ADDENDUM # 4

Re: INVITATION FOR BIDS: **16-035-CW South Bibb Pavilion**

## Addendum: 004 South Bibb Park – Pavilion Package

<b>Project:</b>	South Bibb Park Recreation Center Sardis Church Road & Houston Rd. Macon, Georgia 31216	<b>Issuance Date:</b>	December 28, 2015
<b>Architect:</b>	Schroeder Architects 3118 East Shadowlawn Ave, NE Atlanta, Georgia 30305 Phone: 404.733.2626 Email: <a href="mailto:David@schroeder-architects.com">David@schroeder-architects.com</a>	<b>Job Number:</b>	150501
<b>Owner:</b>	Macon-Bibb County Recreation Department 115 Willie Smokie Glover Drive Macon, Georgia 31201	<b>Contractor:</b>	All Bidding Contractors

**SITE LAYOUT DIAGRAM**

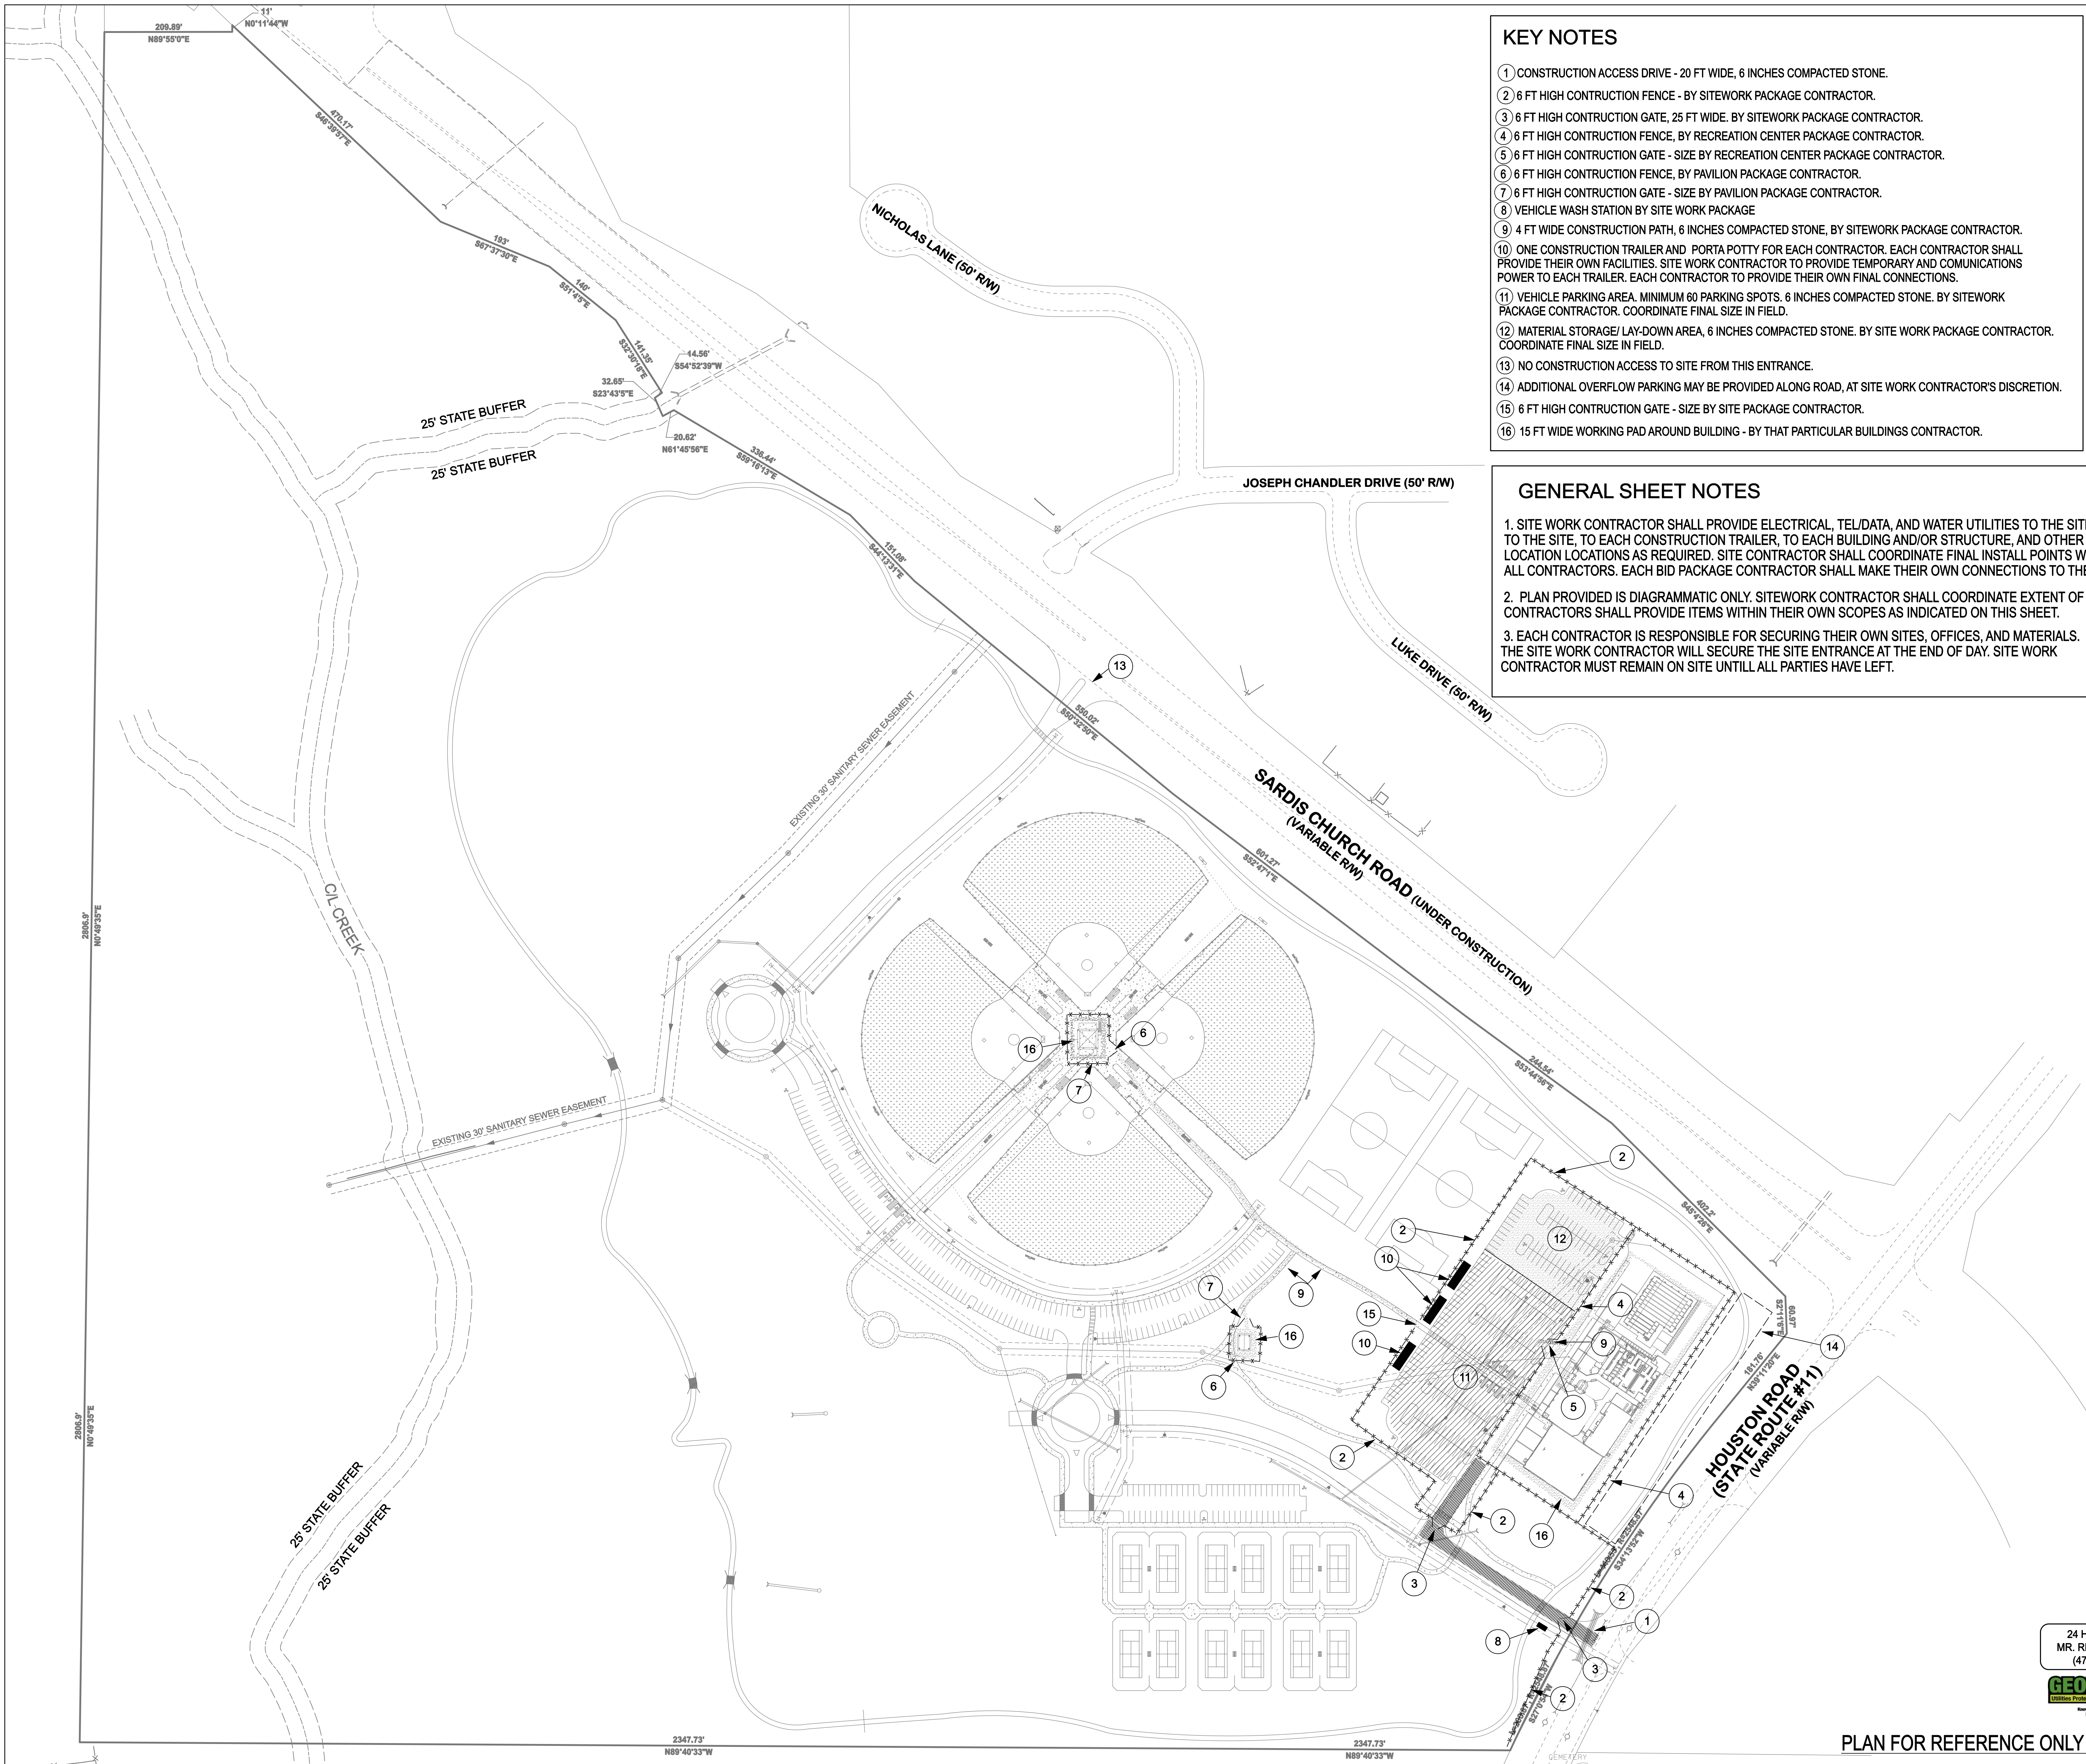
Item	Description
1.1	Civil engineer has created a Site Layout Diagram to assist contractor with coordination between, and site usage by, all the bid packages. This is being issued to all bid packages.
